ORDINARY COUNCIL MEETING

2 APRIL 2024

- 1 FOR ADOPTION - 2024 Subdivision and Development Code, D24/29130 [↓](#)
- 2 Submission 1 - Subdivision and Development Code, D24/28045 [↓](#)
- 3 Response to Submission 1 - Subdivision and Development Code, D24/29131 [↓](#)
- 4 Submission 2 - Subdivision and Development Code, D24/27943 [↓](#)
- 5 Response to Submission 2 - Subdivision and Development Code, D24/29132 [↓](#)

ORANGE CITY COUNCIL SUBDIVISION CODE STANDARD DRAWINGS

SHEET No. 41 OF 100

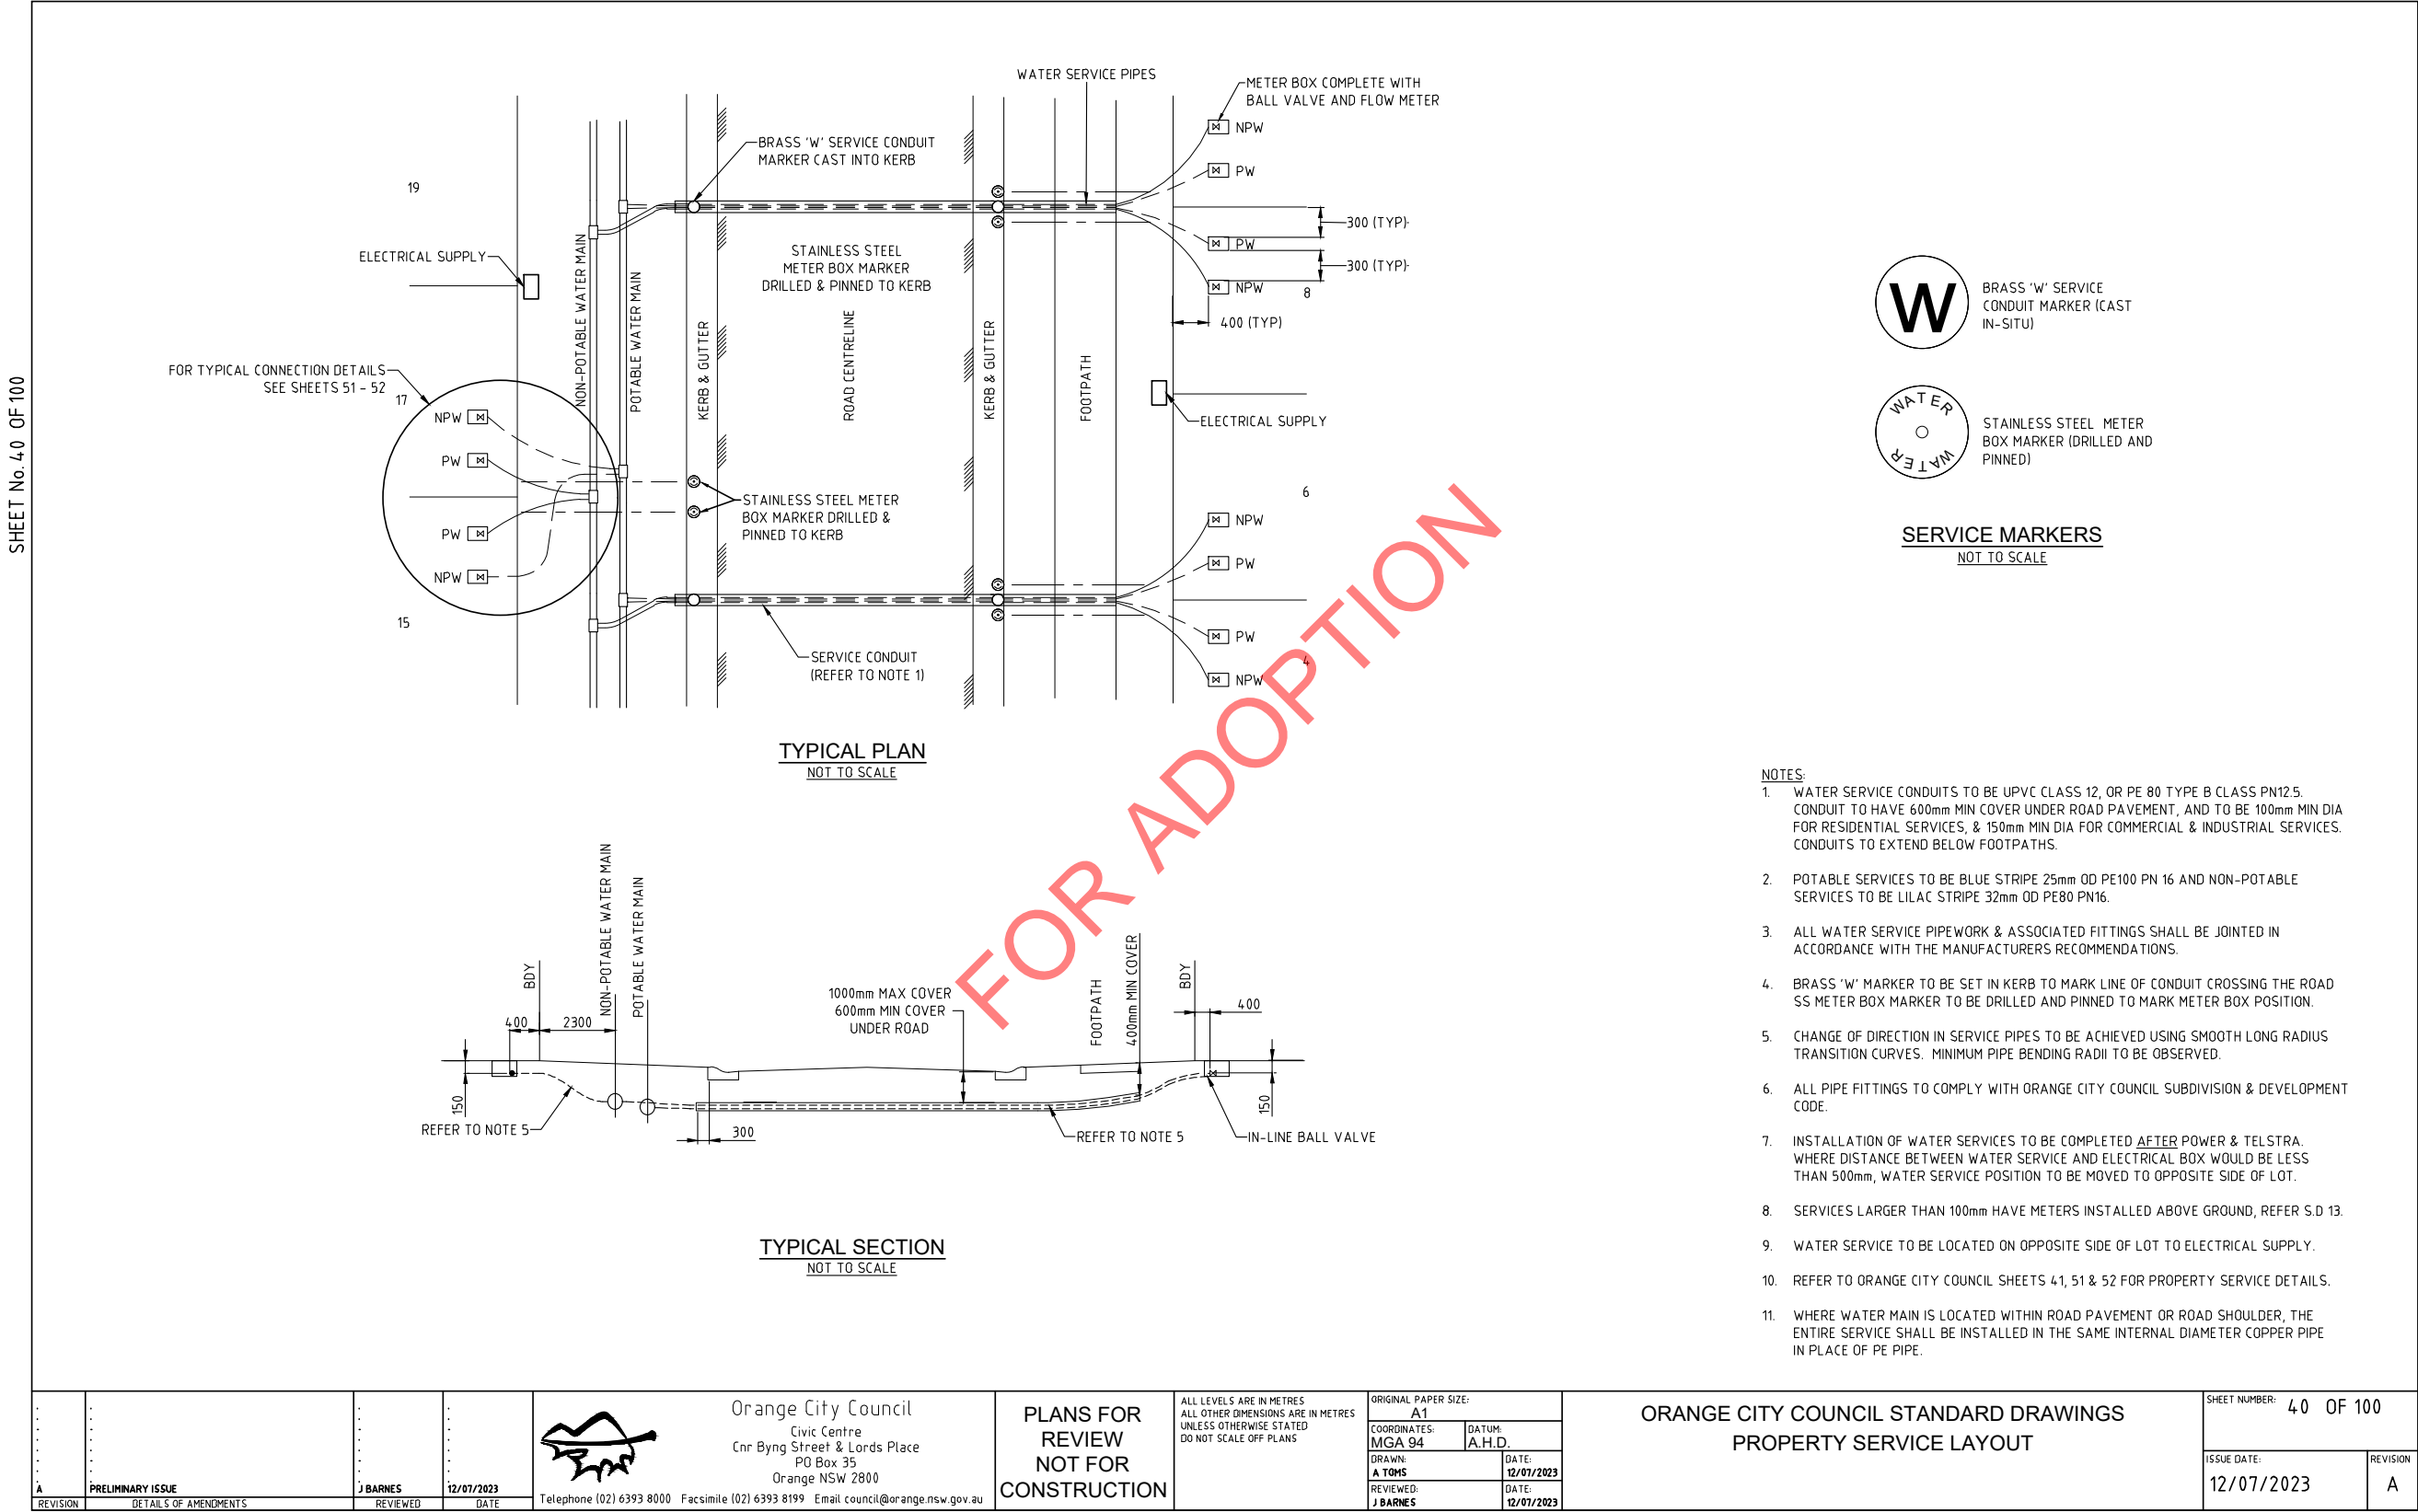
| 152 | Sheets 40 & 41 | | Termination points inside property boundary are contradictory between Sheets 40 & 41 for residential 20/25mm services. Sheet 40 shows poly pipe to the in line ball valve. Is Council going to comply with service markers when they install services?? | Agreed, This will be amended on revised standard drawings - services to terminate 400mm inside proeprty boundary. 20, 25 & 32mm water services are to be PE with copper tail. Sheet 40 indicatively showing PE pipe extending to meter, with the main purpose of this drawing is to show the service arrangements from the main. |

SHEET No.59 OF 100

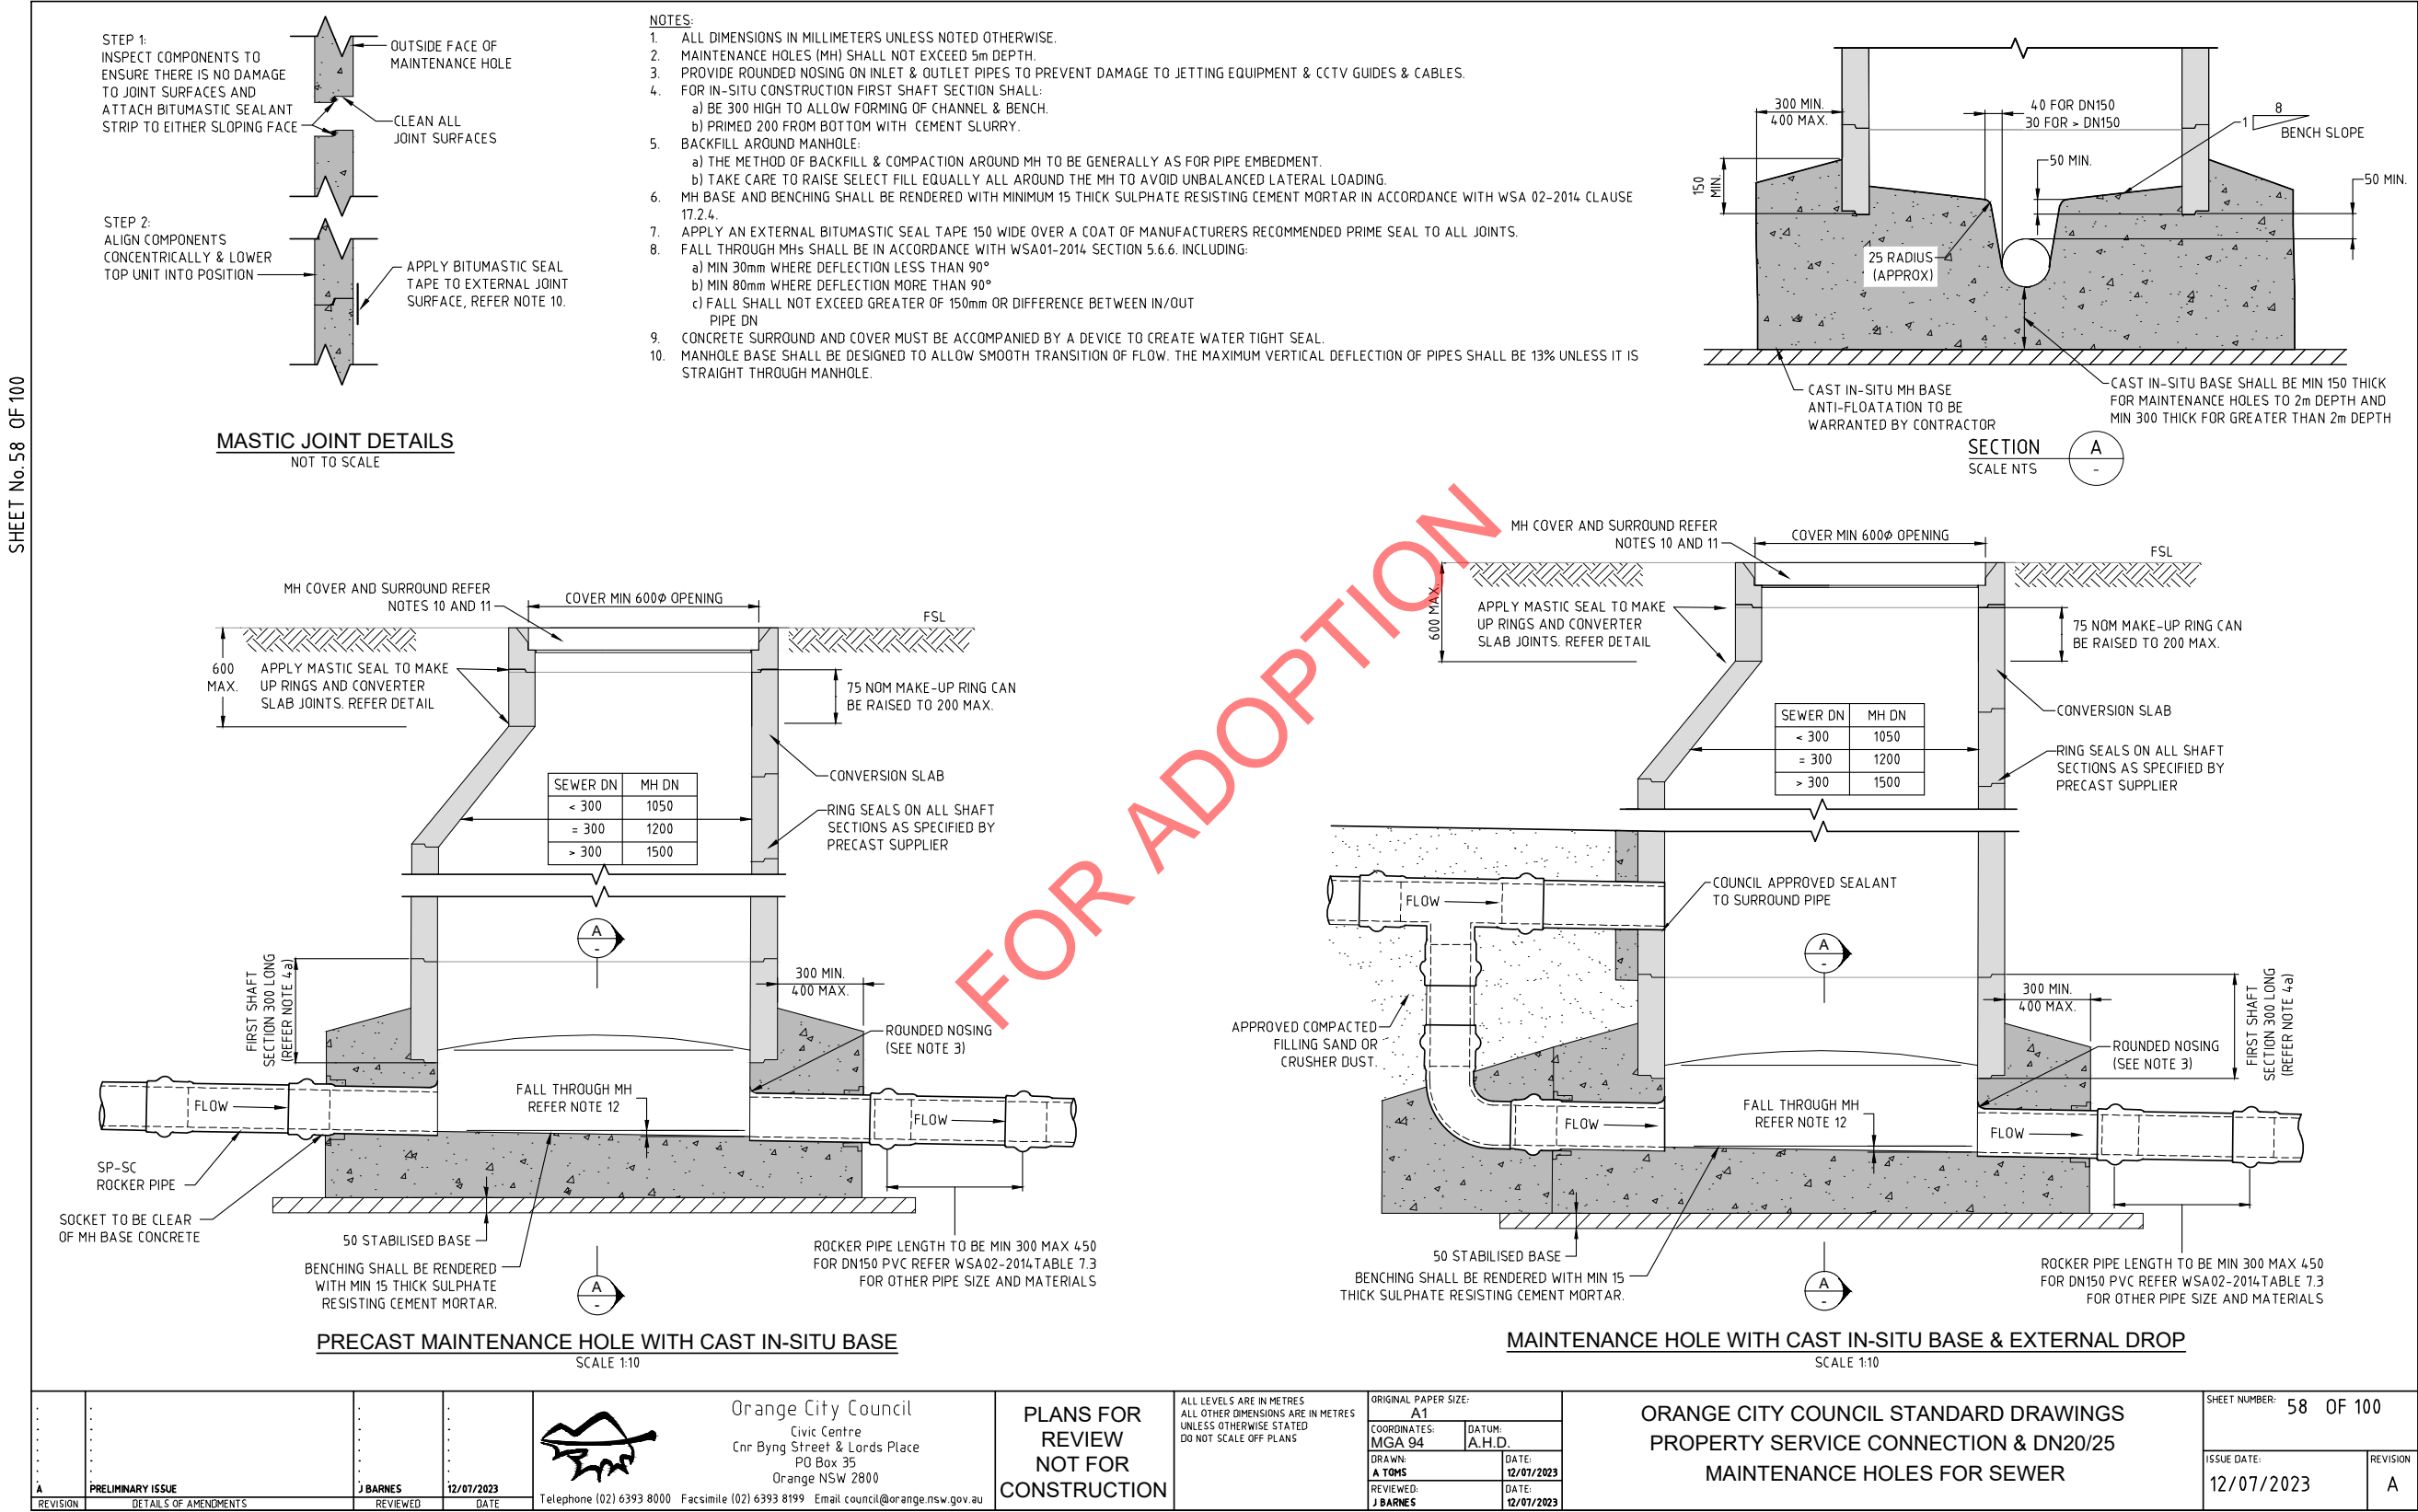
| 159 | Sheets 63 - 100 | | This drawing now refers to 100 in the set whereas previous drawing refer to 39 in the set? Have not actually checked these drawings as they appear as though they have been copied from the WSA Code. Assuming Council have necessary copyright clearances to reproduce these drawings on their own title blocks. | Agreed, Drawing numbers to be updated in final set. No Change, These drawings have been developed by Council, not copied from WSA Code. |
